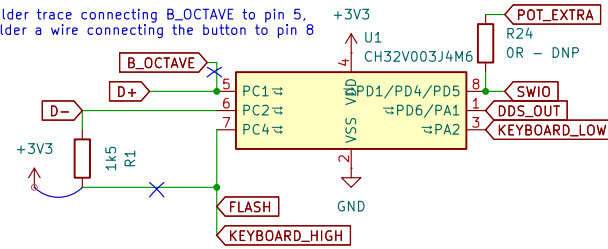
Cut the solder trace connecting B_OCTAVE to pin 5, instead solder a wire connecting the button to pin 8

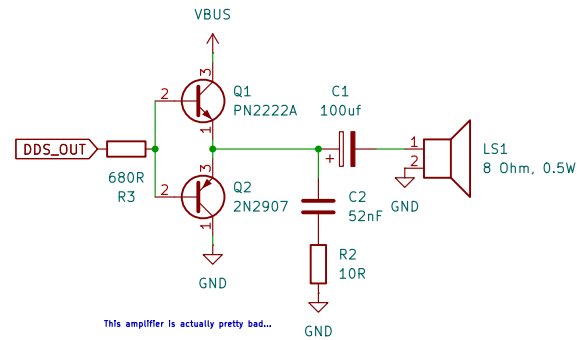
Mistakes that made it to the production:
The resistor must be connected between 3v3 and PC2 instead
(this can be fixed on board by connecting the upper leg of the resistor to left pin of a C5 instead)
